STATE OF HAWAII  
DEPARTMENT OF TRANSPORTATION  
HIGHWAYS DIVISION

ADDENDUM NO. 1

SIDEWALK REPAIRS AT VARIOUS LOCATIONS

PROJECT NO. HWY-OM-2011-38R

**STANDARD PLAN D-15  
CONCRETE SIDEWALK**

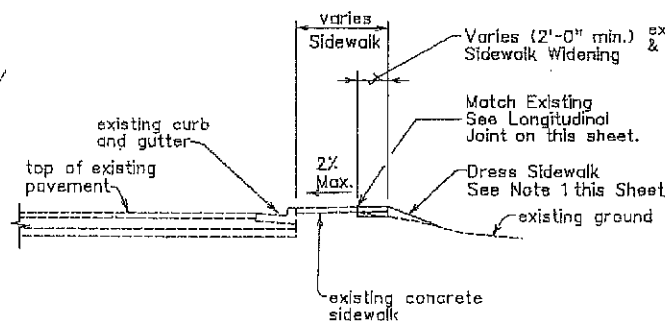
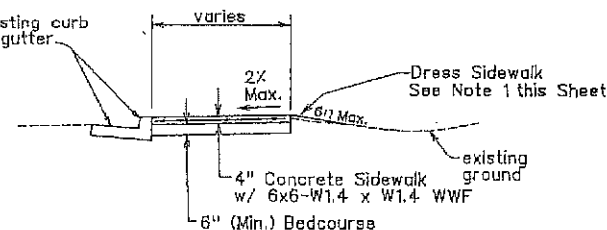
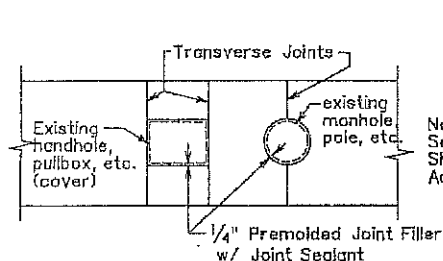
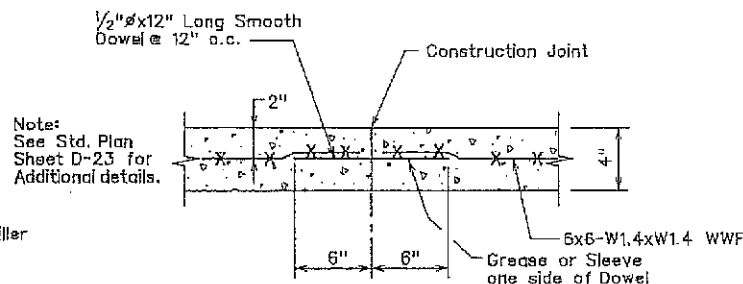
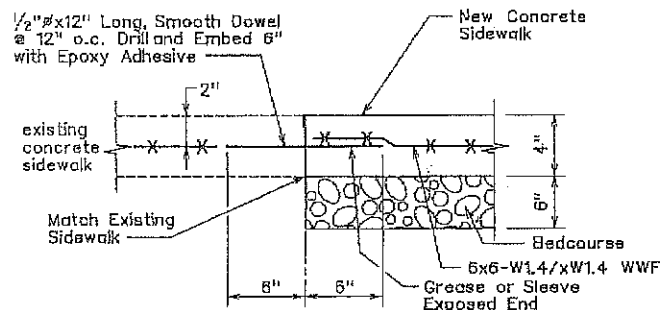
The attached standard plan sheet shall be incorporated and made part of the Special Provisions.

7. Can a typical section of the sidewalk be added to the bid documents?

**Yes. HDOT's standard sidewalk plan is included in the addendum.**
